4. COA-075150-2020

2004 West Grace Street

STAFF REPORT

Alter a side porch and convert a window to a door on the side elevation.

Figure 1. Sanborn Map, 1950

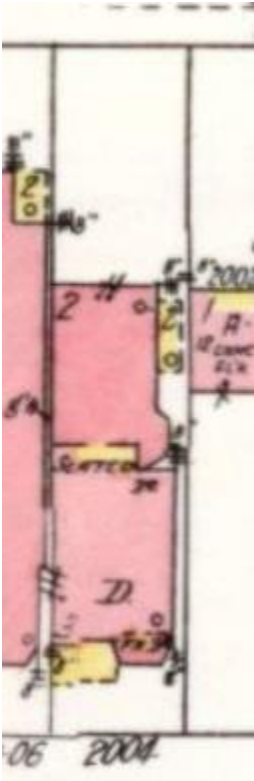
The applicant is also proposing to alter the design of the stairs that access the side porch from the front and rear yards. It is clear that the rear stairs are of modern construction. The 1950 Sanborn map shows no evidence of the stairs or side landing. In addition, these stairs are not visible from the public right of way due to an existing privacy fence. Staff recommends approval of the proposed changes to the rear stairway.
